Architectural Review Board Staff Report

November 9, 2023 6:00 PM

Construction aerial of St. Charles Black roof is the old gym

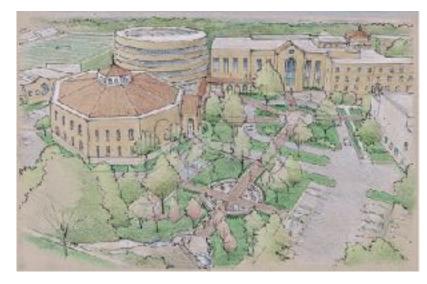
The applicant is seeking design review and a recommendation to the BZAP, as there is a variance from Bexley Code Section 1254.10 which limits the maximum height to 3 stories or 45 feet, to modify and build on the existing gym footprint, and allow the addition to match the height of the existing structure south of the old gym. (has an overall height of 49' – I believe)

The design of this new addition seems clear in its form, placement and program. The applicant will have an opportunity at the meeting to discuss and explain the materials and the differences between the rendering and the elevations - cornice arches, details, colors, etc...

- A recommendation to BZAP by the ARB can request a remand back to ARB for final design review.
- Final Design to be reviewed and approved by the city's Design Consultant
